**Reagan National Airport
Community Working Group
Recommendation # 8
(Approved July 27, 2017)**

Consensus Position for South Flow Departures:

Figure 1

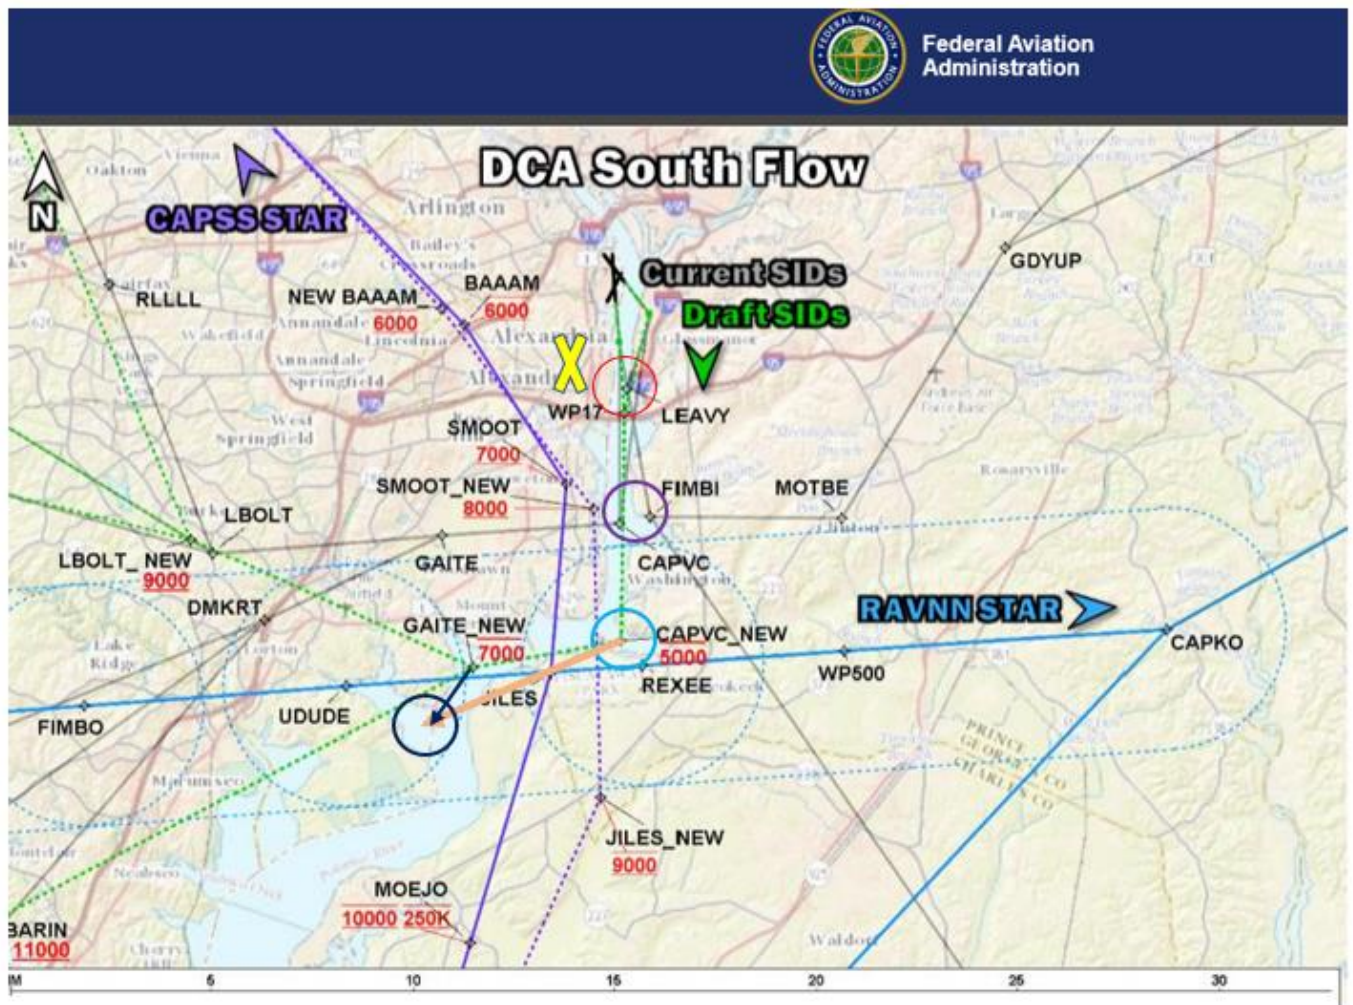
1. Except for turboprop and operational emergencies, eliminate early transition turns to the west over Alexandria City. **See yellow X**
2. Combine Waypoint (WP) 17 and WP Levy and implement 1 WP centered over the Potomac River before crossing the Wilson Bridge. **See red circle on Figure 1**

3. Keep South Flow departures centered over the Potomac River.
4. Move current WP FIMBI west towards the Potomac River closer to where current CAP VC WP is located. Airplanes heading east and northeast will still make east transition turn at FIMBI. **See purple circle on Figure 1.**

6. Move the CAPVC New WP further west over the Potomac River enough to avoid crossing land near Fort Washington. **See light blue circle on Figure 1.** At the CAPVC New WP make a right turn climbing to 7000 ft. or higher towards Gaithe New WP.

7. Move Gaithe New WP further south to a point south of Fort Belvoir, Virginia and north of Mason Neck. **See dark blue circle and arrow on Figure 1.**
